SAFETY EVALUATION REPORT

**License Renewal of the Willow Creek
Uranium In Situ Recovery Project
Johnson and Campbell Counties,
Wyoming, Materials License No.
SUA-1341**

**Docket No. 040-08502
URANIUM ONE USA, INC.**

March 2013

Figure 5.1. Uranium One Radiation Safety and Environmental Protection Organizational Chart

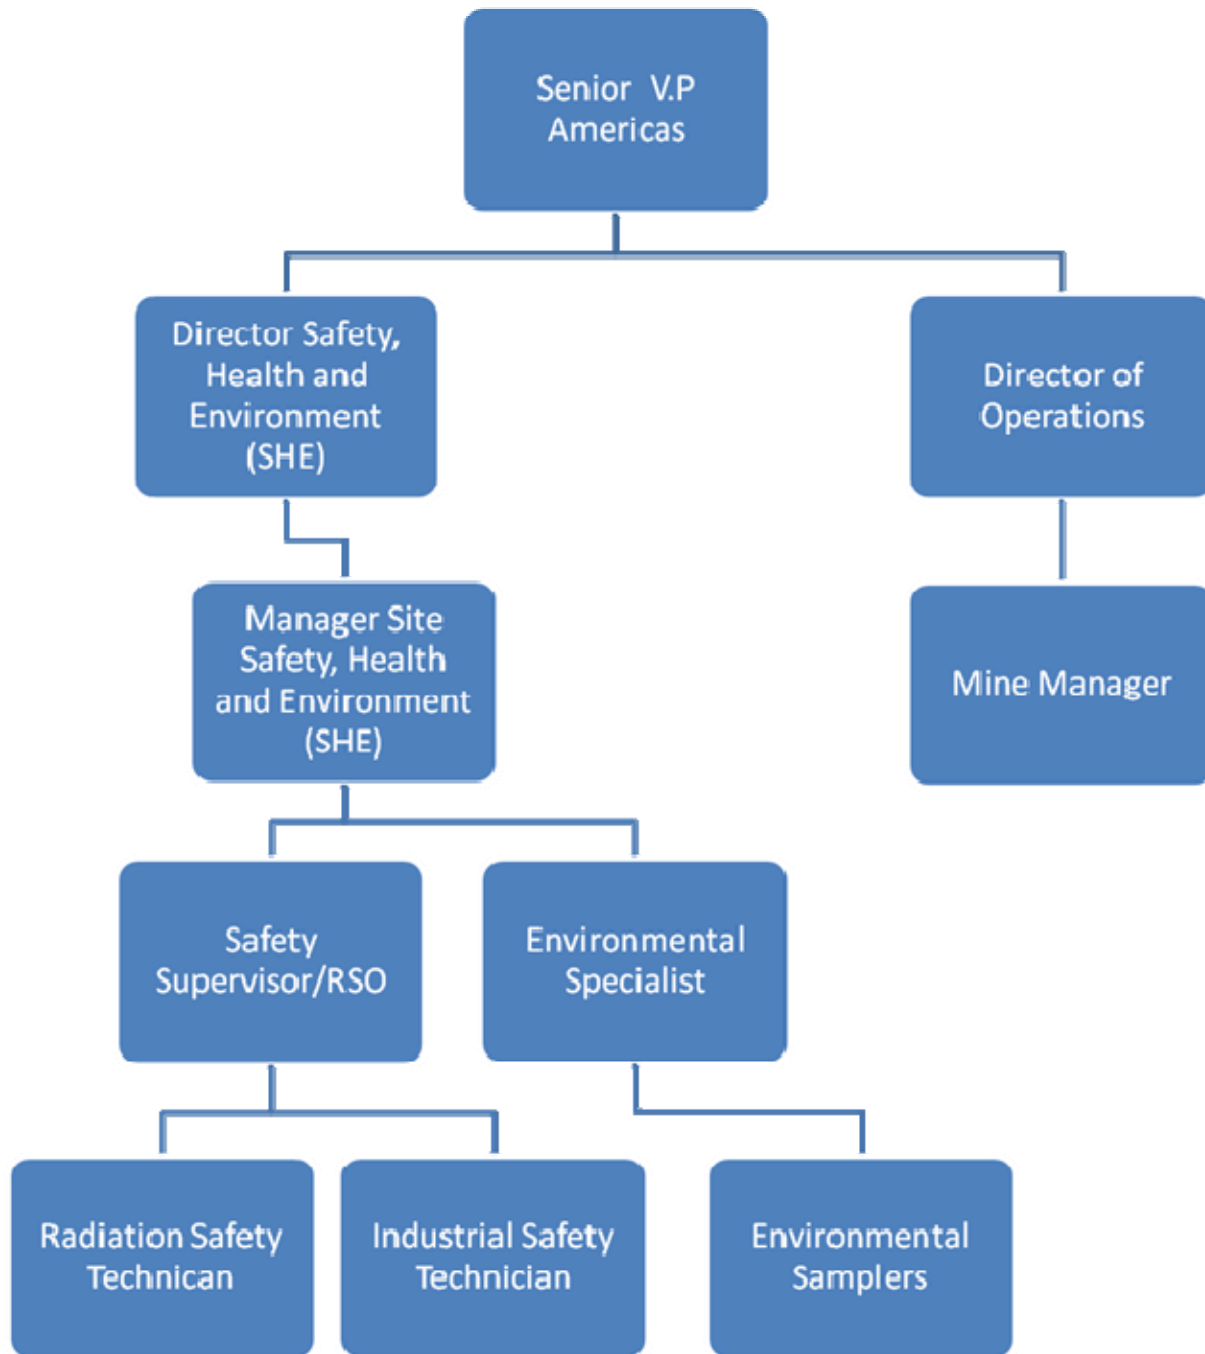
The NRC has received notice that the management structure has changed (Uranium One, 2012d). The current Uranium One Radiation Safety and Environmental Protection Organizational Chart is displayed in SER Figure 5.1.

The NRC staff notes that under the new management structure, the RSO reports to the Manager, Site Safety, Health and Environment, who in turn reports to the Director, Safety, Health and Environment. In this structure, the RSO has been removed from the Operational chain of command. Ultimately, the RSO reports to the Senior Vice President, ISR Operations. The NRC staff observes that the licensee has not updated the LRA to reflect these management changes and expects the licensee to do so through the Safety and Environmental Review Panel (SERP) process and report the changes to the changes to the NRC in its annual SERP report as required by license condition 9.4.

Figure 5.7 Willow Creek Project surface monitoring locations

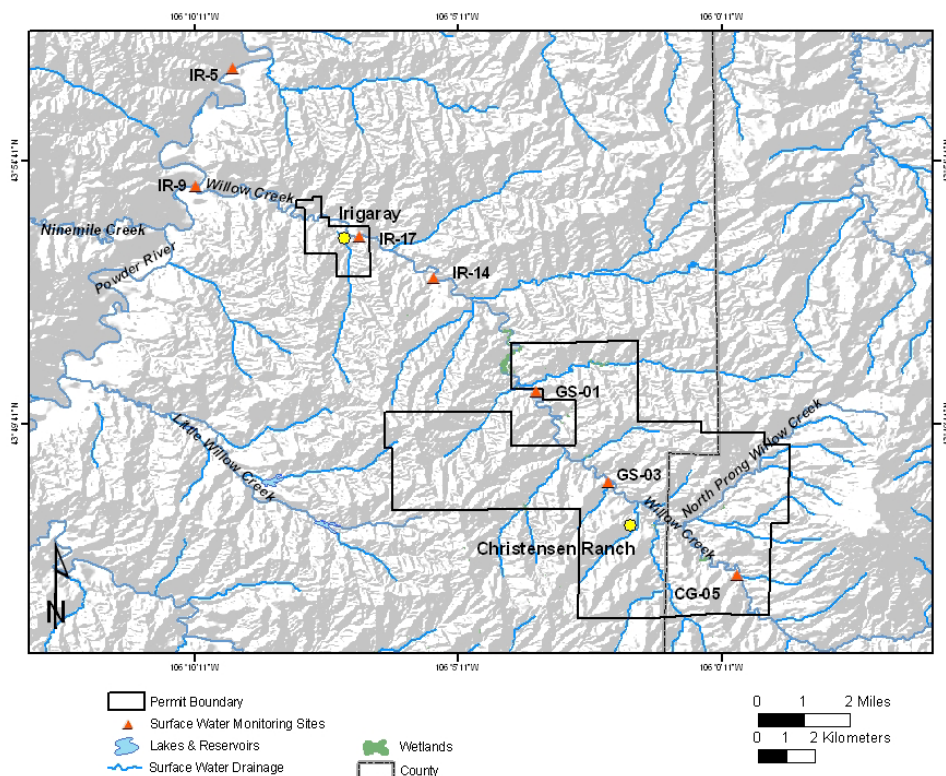
The NRC staff has determined that the licensee's sampling location GS-01 is upstream of the Heldt Draw drainage basin, and likely will not capture runoff from the Heldt Draw area resulting in runoff from operations not being sampled at the license boundary, as stated previously by the

licensee. During inspections at the site, the NRC staff determined that there are no sampling points on Willow Creek suitable for water sampling at the license boundary. Staff also notes sampling point IR-14 is approximately 3 km downstream of the license boundary and will provide continued sampling of all runoff from Christensen Ranch. The NRC staff finds the licensee's surface water program acceptable as it conforms to the guidance criteria in standard review plan Section 5.7.8.3 (NRC, 2003).

Figure 6.1 Historical reverse osmosis/permeate injection pore volumes (IR—Irigaray, CR—Christensen Ranch) (COGEMA, 2005b; 2008b).

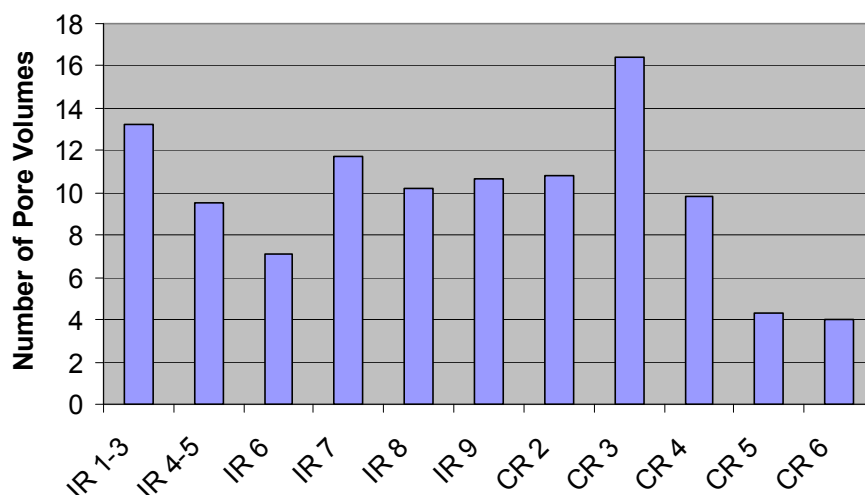
The pore volumes and flow rates that the licensee proposed in the previous LRA (COGEMA, 1996) and current LRA for different restoration phases shown in SER Table 6.1. SER Figure 6.1 shows the historical pore volumes used during the RO/permeate injection phase, where the average is about 10. On the basis of the past restoration experience, the licensee increased the number of pore volumes to be used during the RO/permeate injection phase to 10 (COGEMA, 2009a), leading to a total of 12 pore volumes used during restoration. The licensee also indicates that the relatively larger number of pore volumes used for Christensen Ranch MU's 2 and 3 were related to the larger impacted mining zones associated with those wellfields, whereas the planned wellfields at Christensen Ranch will be more in line with Christensen Ranch MU's 5 and 6.

The NRC staff agrees with the licensee's proposal of using up to 10 pore volumes for RO/permeate injection phase for restoration and 10 pore volumes for RO/permeate injection for the calculation of surety. The staff previously has approved the Willow Creek Project restoration process (NRC, 1998) and the staff has found nothing to invalidate or call into question its previous findings; therefore, the original findings and staff's prior conclusions remain valid.
